ADDENDUM #9

RE: Addendum #9
Electronic Access & Video Surveillance
Tyler Junior College
RFP #24-07

LOUISE H. & JOSEPH Z.
ORNELAS RESIDENCE
HALLS
SECOND FLOOR PLAN
SHEET 4 OF 6

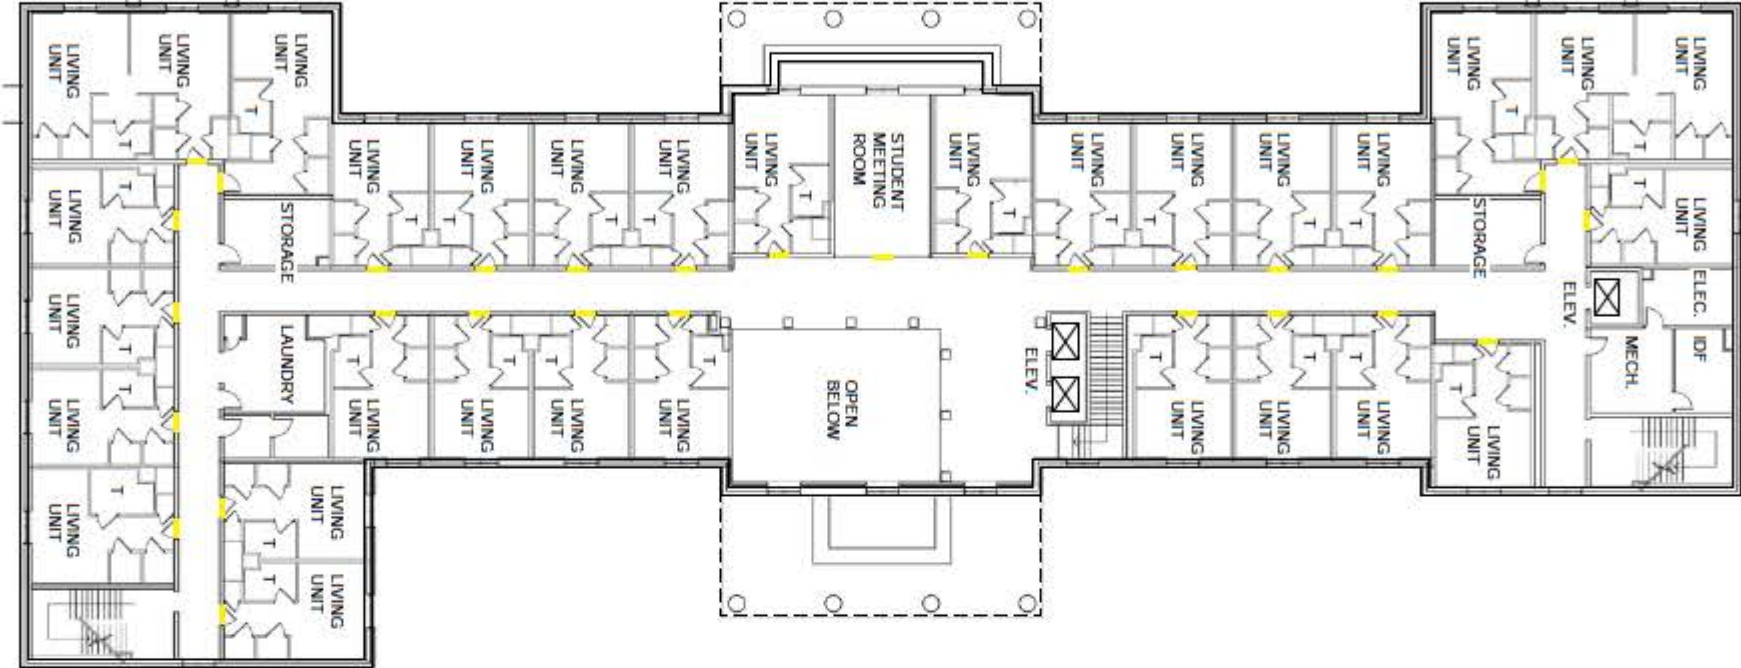
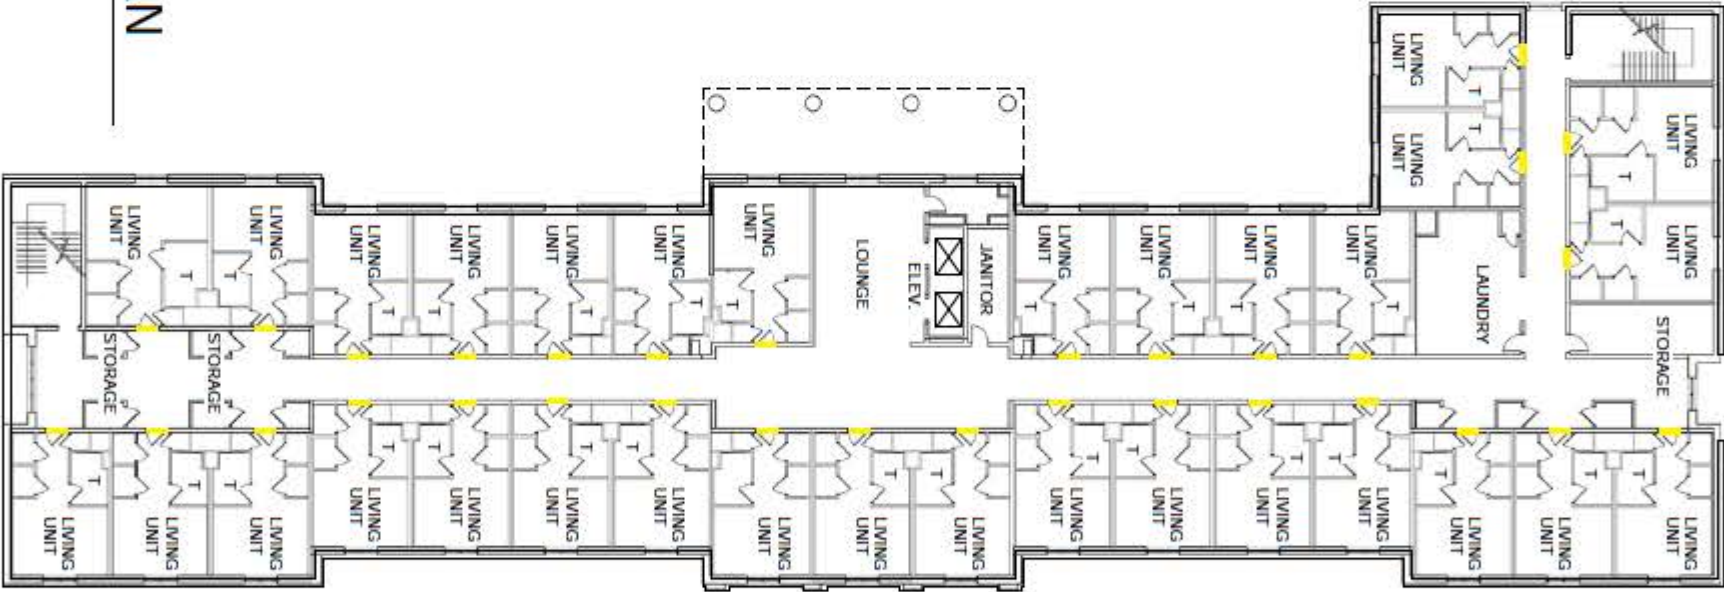
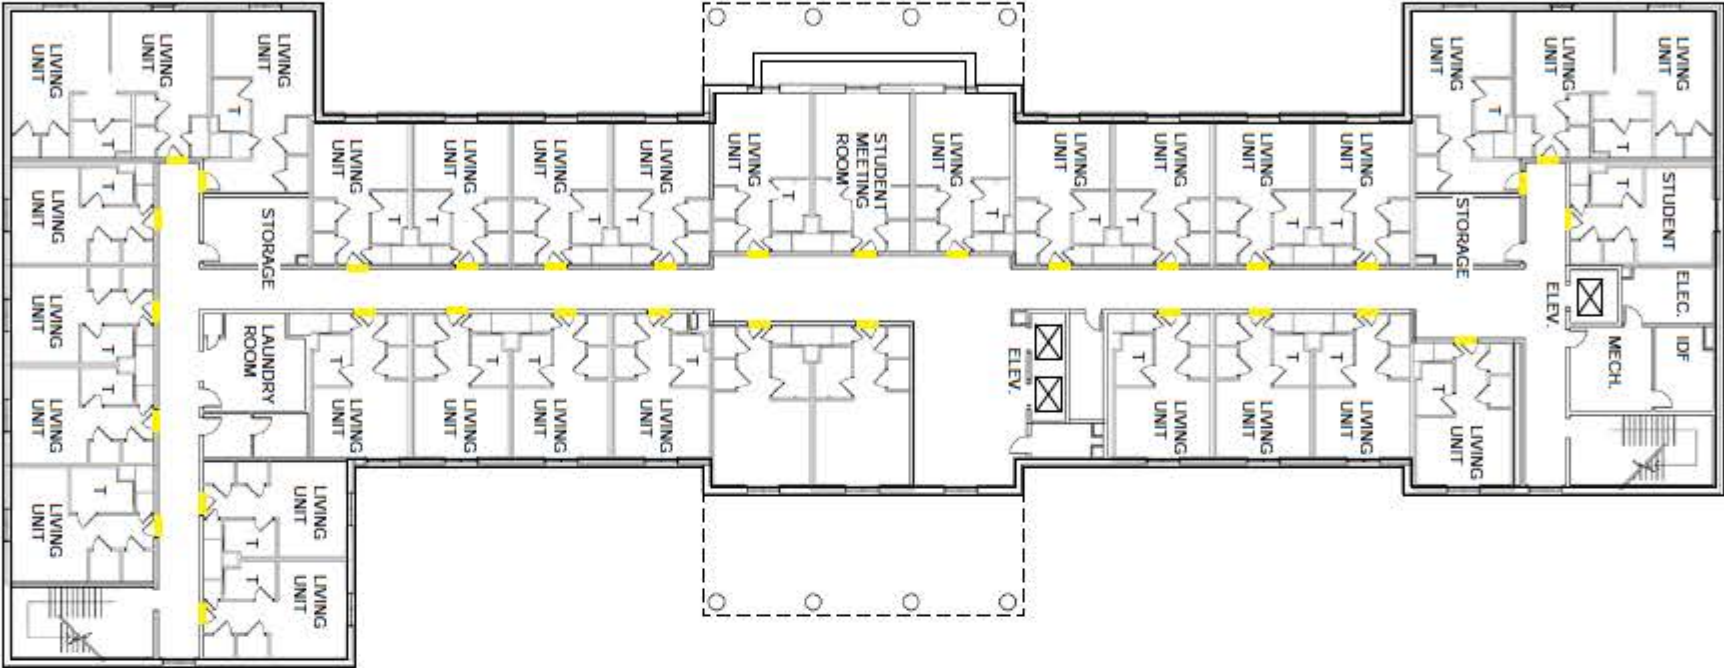
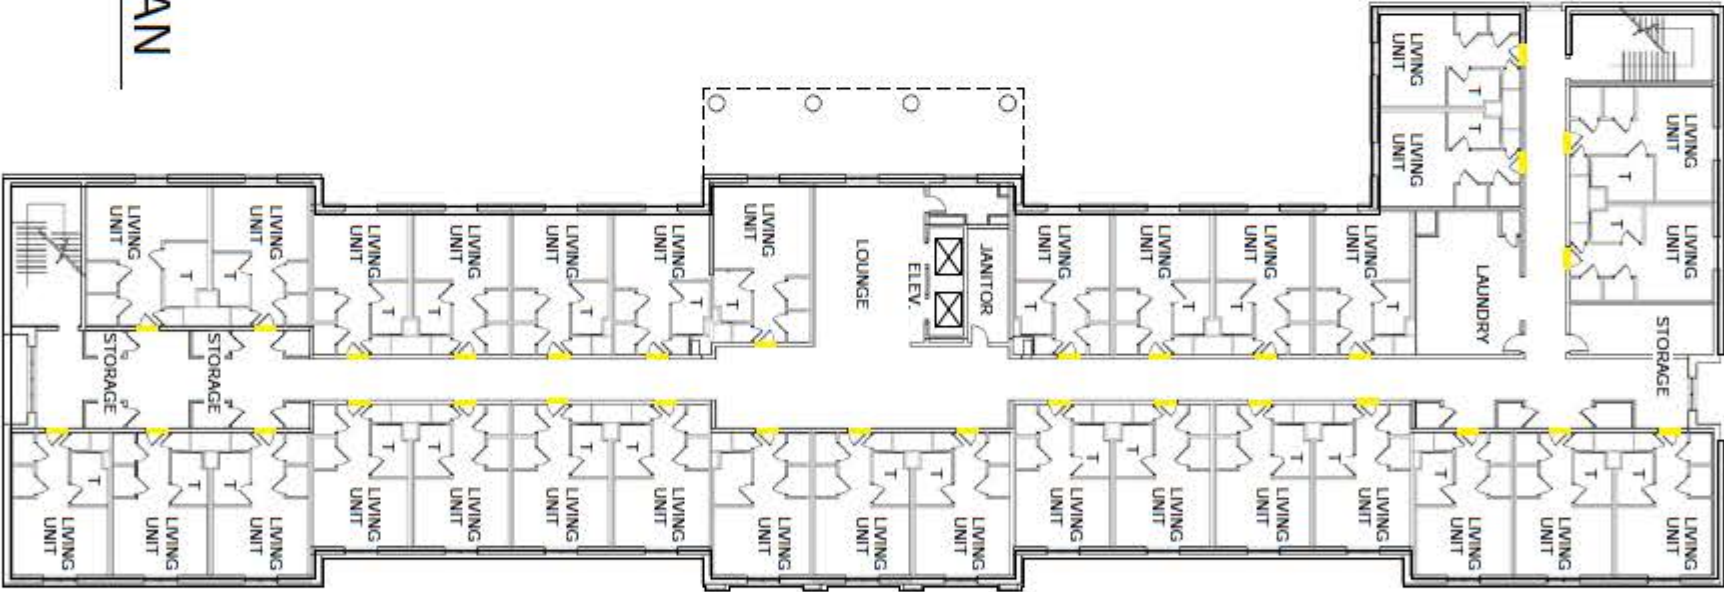
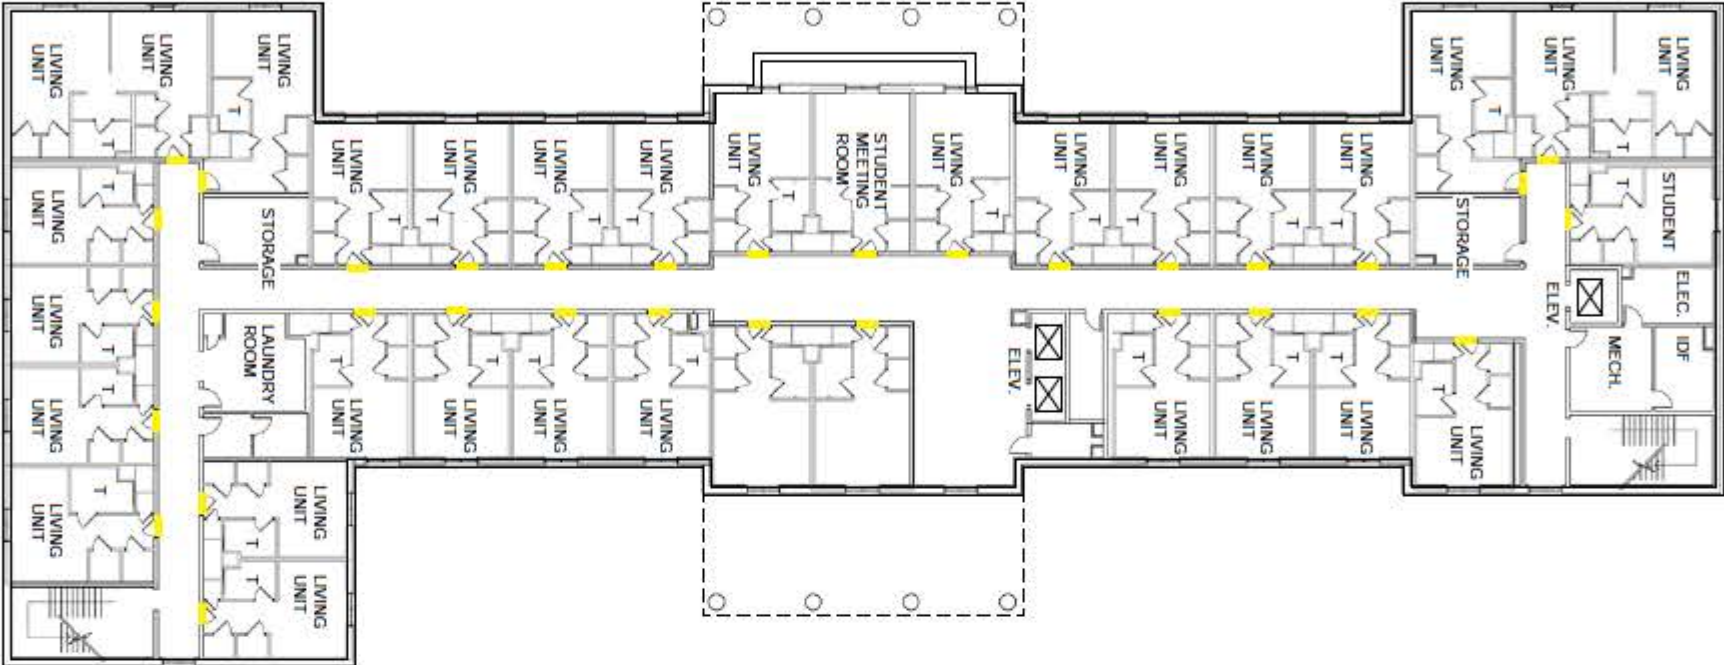
QUESTION #18: Addendum 5, Binder #2: Doors types, counts, closets are not given for the second, third, and fourth floors of Ornelas Hall, page 60, 61 and 62.

QUESTION #39: The provided floorplans for Ornelas Hall do not contain the color coding for having Onity locks. Should we include in our design to include locks for the dorm rooms in this building also?

ANSWER: Floor plans for the 2nd-4th floor of Ornelas Halls have been attached with the Onity doors marked.

ANSWER: See attached map.

Pat Hartley Field Complex

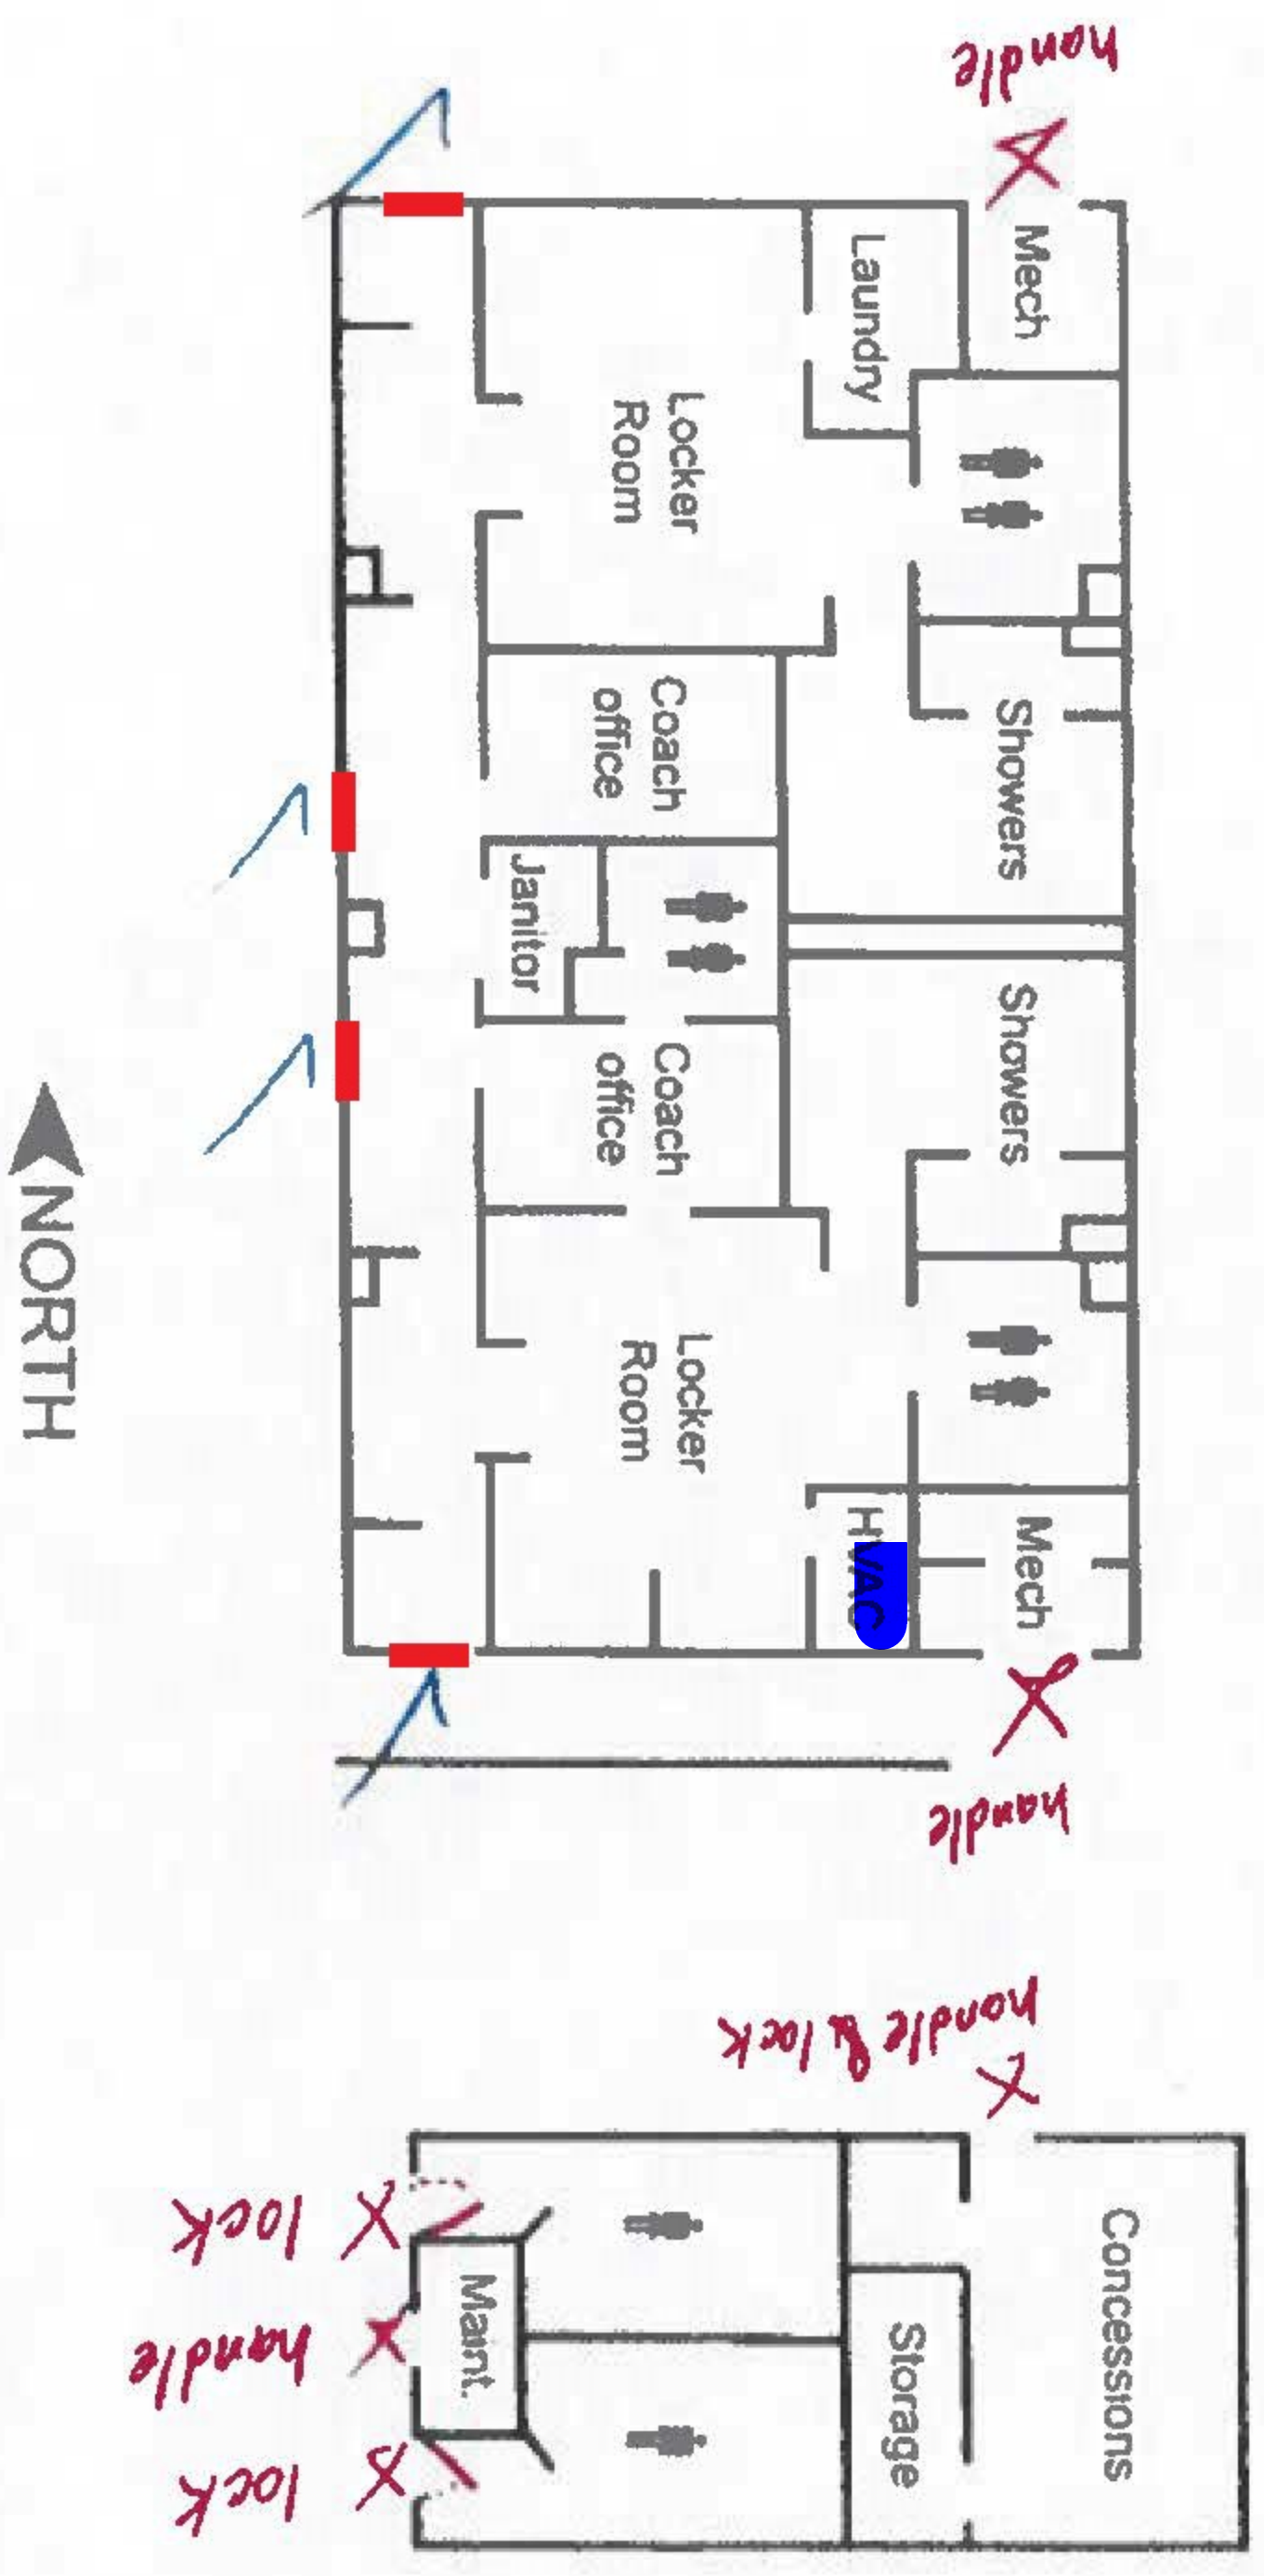
QUESTION #11: Addendum 5, Binder #1: At the Pat Hartley building, page 37, please identify the door needs. The door legend is not utilized on these pages. Are all of these doors considered “exterior without access control”? What is the cable path to the concessions center?

ANSWER: An updated floor plan for the Pat Hartley building has been attached with the doors and IDF marked. The concession center will not have access control.
